REVISIONS

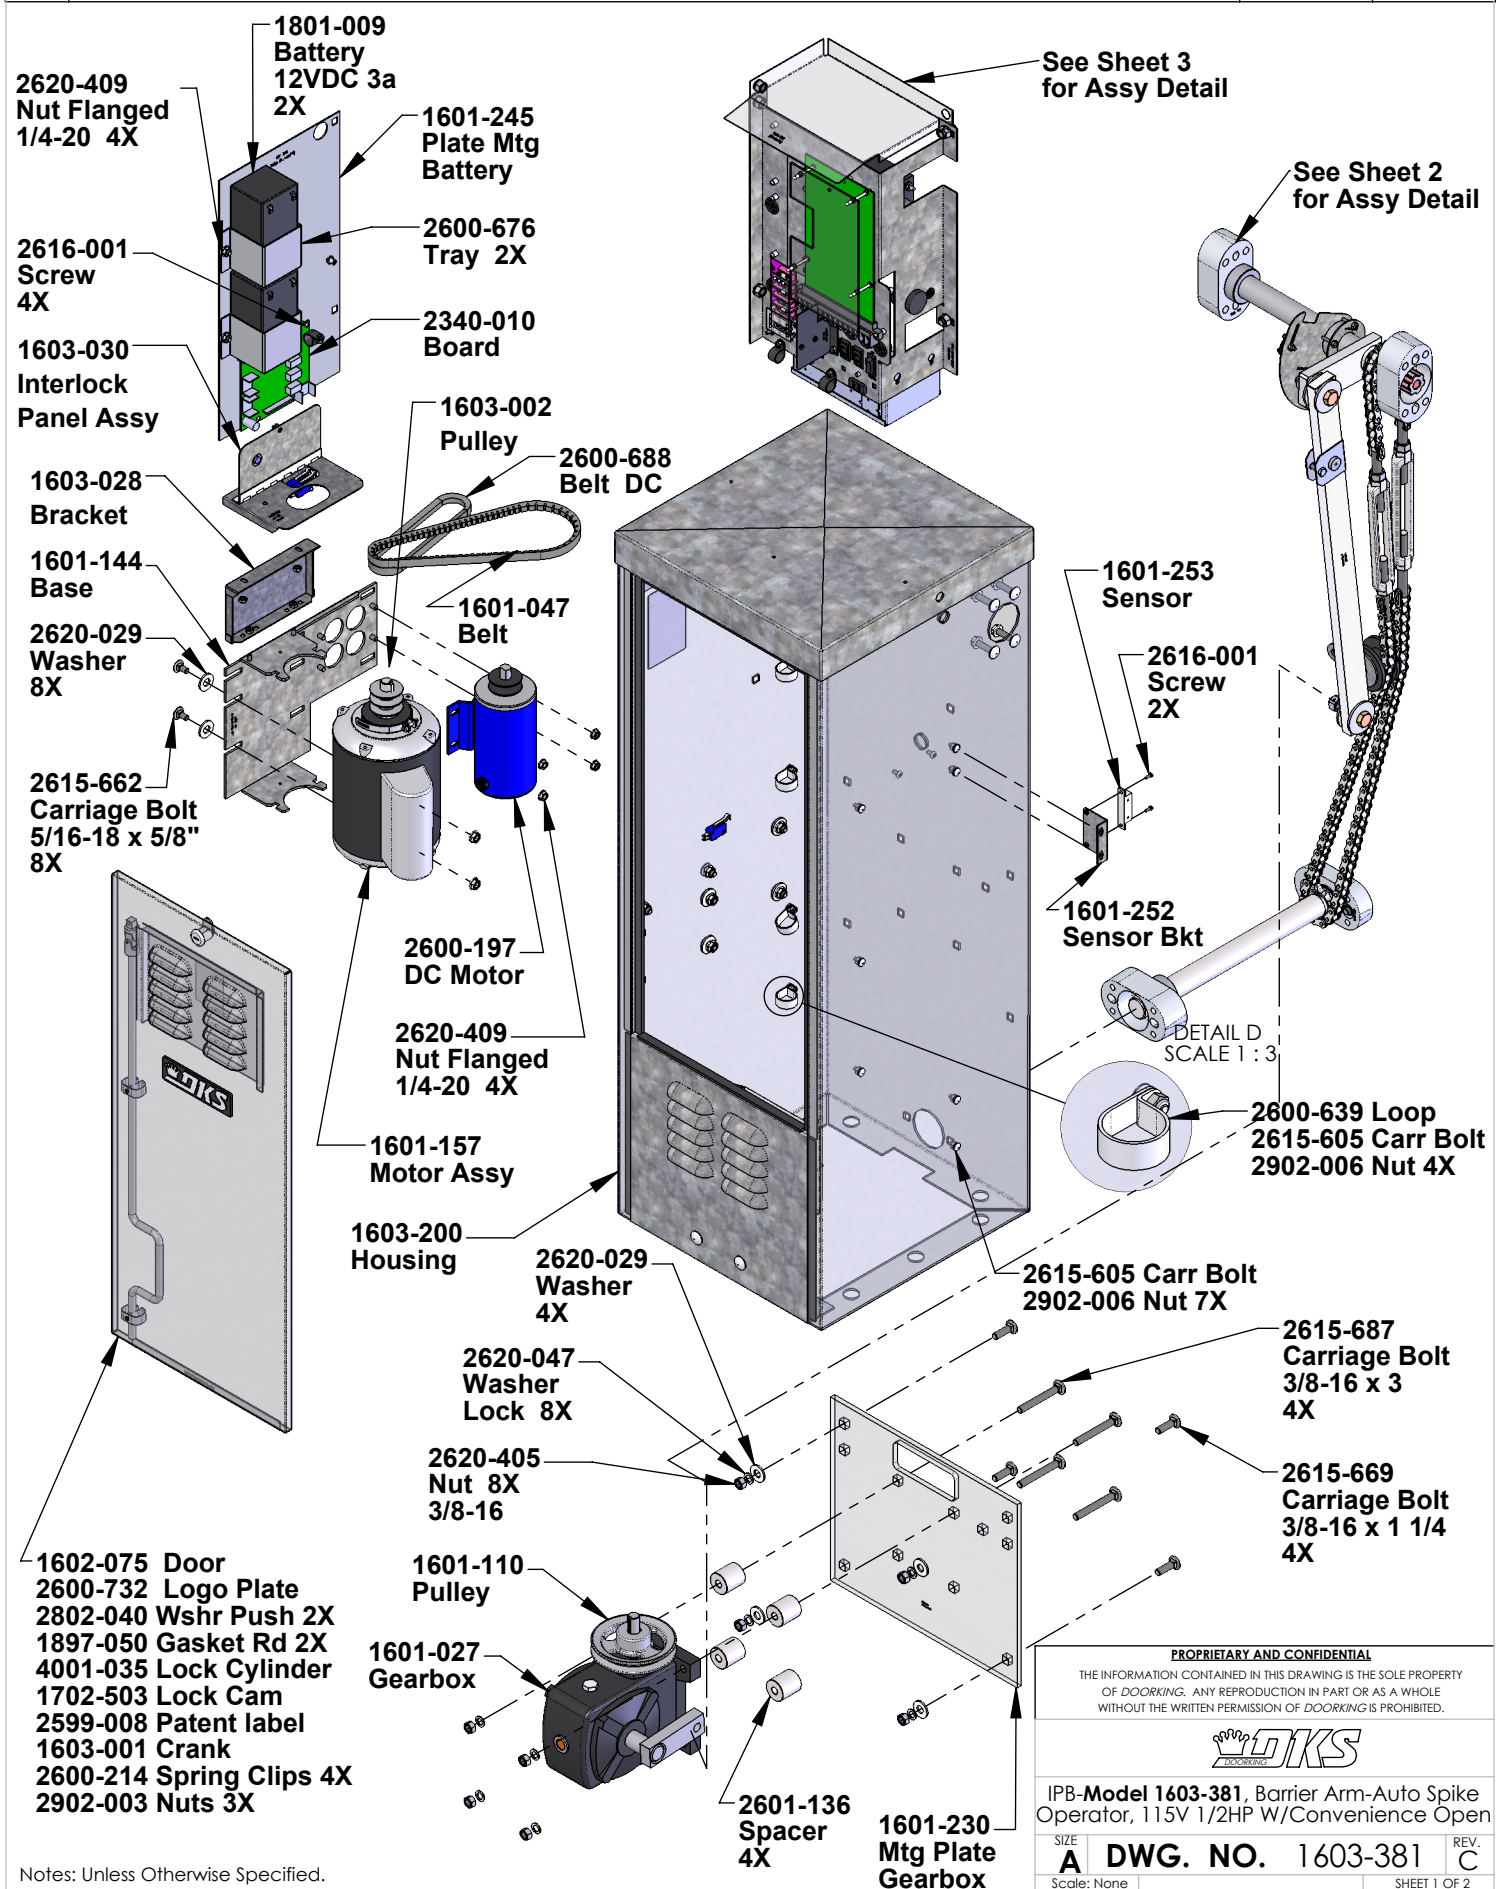
REV.	DESCRIPTION	DATE	APPROVED
B	Change to 4 bolts on bushin block, remove top carriage3 bolts replace with K.O.	8/30/2024	DC
C	Change 1603-226 to 1601-246, Replace upper spacer 2601-134 with 1601-032 Bushing	1/1/2026	DC
